City of FRESNO

CITY OF FRESNO – ADDENDUM NO. 1

RIVER WEST FRESNO EATON TRAIL EXTENSION, PHASE 1

BID FILE NUMBER: 12700455

CONSTRUCTION SKETCH
9539 N BLACKSTONE AVE
FRESNO

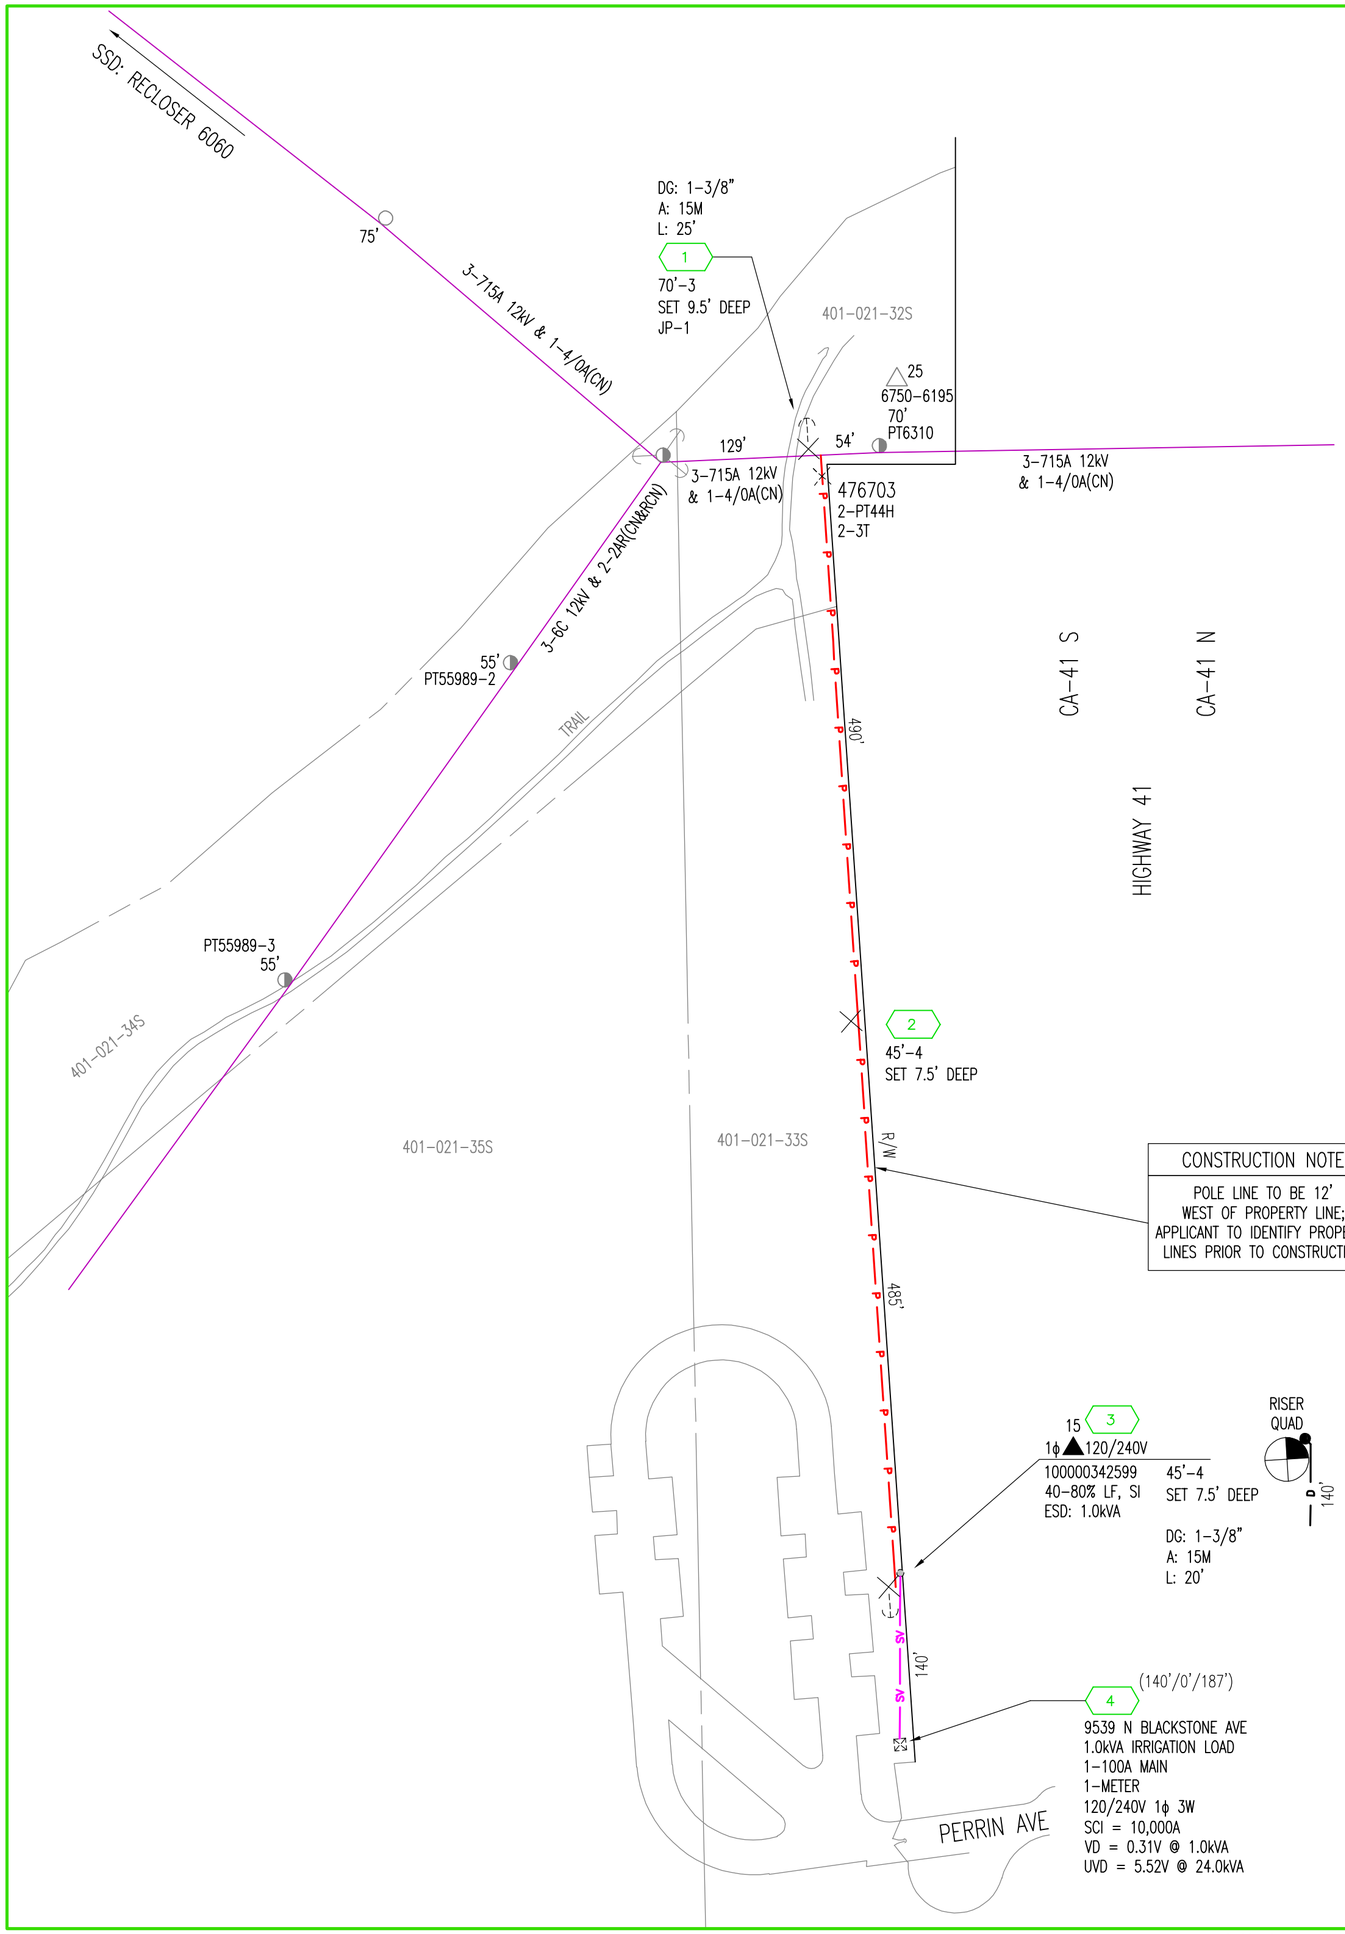
9. Clarification for PG&E Point of Service added on Sheets 15-E-14689 and 15-E-14708:

- Remove and Replace Sheets No. Sheets 15-E-14689 and 15-E-14708, Sheets 108 and 127 of 133, entirely with Addendum No. 1 Drawing Sheets No. 15-E-14689 (Addendum No. 1) and 15-E-14708 (Addendum No. 1), (clouded and marked ADDENDUM NO. 1) which adds reference to PG&E new service and Tesco locations.

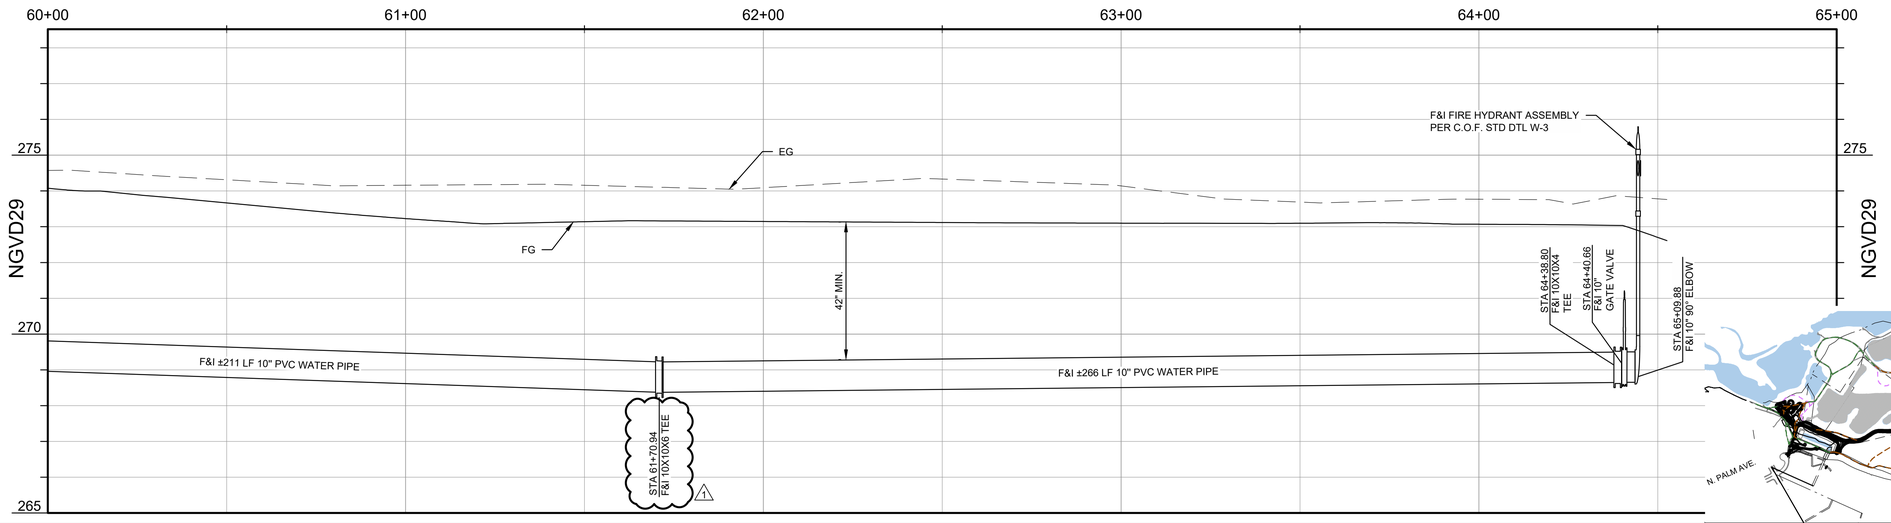
- Modification of Backflow prevention device callout on Sheet 15-E-14648, Sheet 67 of 133. F&I NEW 10" BACKFLOW PREVENTION DEVICE **WITH LOW-FLOW BYPASS METER. LOW FLOW BYPASS METER SHALL HAVE AN INTEGRATED RP DEVICE**"

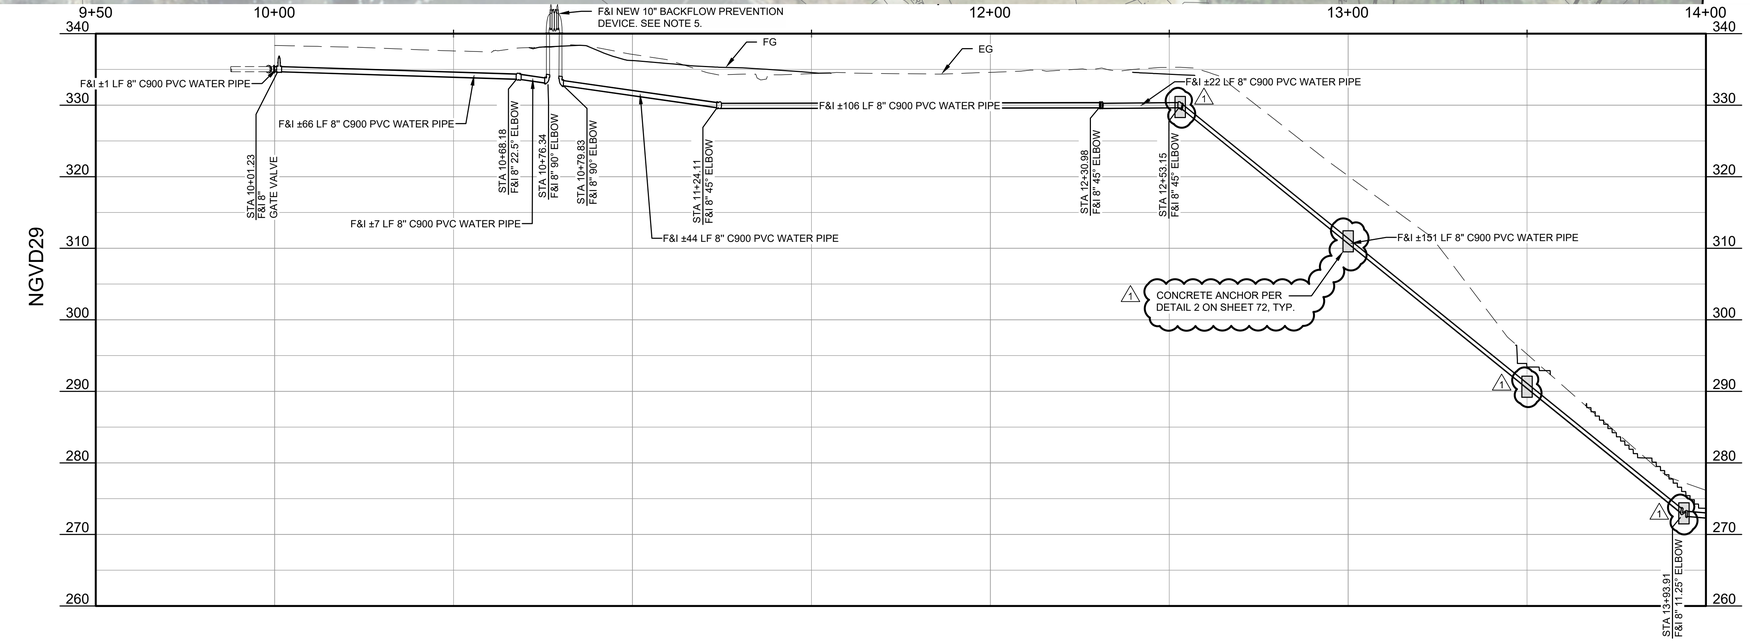
- Fire service line, 2" domestic water service line & 2" irrigation line to be supported by concrete anchor between Spano Park station 12+54 to Station 13+95. Spacing shall be 50' as shown on Sheet 15-E-14649 (Addendum No.1), Sheet 68 of 133.

CONCRETE ANCHOR PER DETAIL 2 ON SHEET 72, TYP.

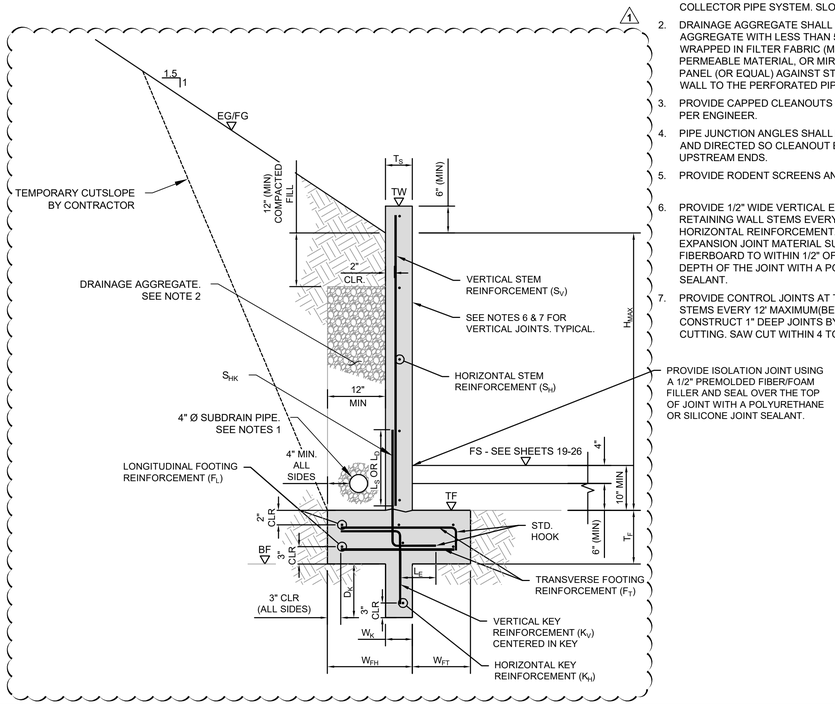
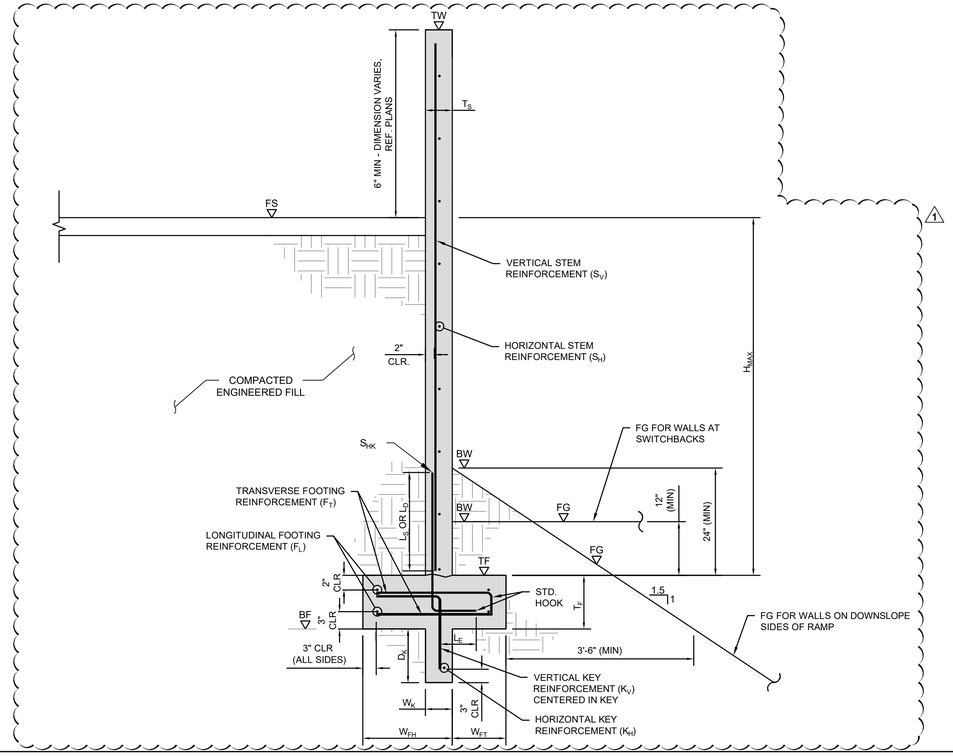
7. Modification to Detail 1 "Walls on Upslope Sides of Ramps" and Detail 2 "Walls at Switchbacks and on Downslope Sides of Ramps" on Plan Sheet 15-E-14655:

- Remove and Replace Sheet No. 15-E-14655, Sheet 74 of 133, entirely with Addendum No. 1 Drawing Sheet No. 15-E-14636E (Addendum No. 1), (clouded and marked ADDENDUM NO. 1) which modifies Detail 1 and Detail 2.
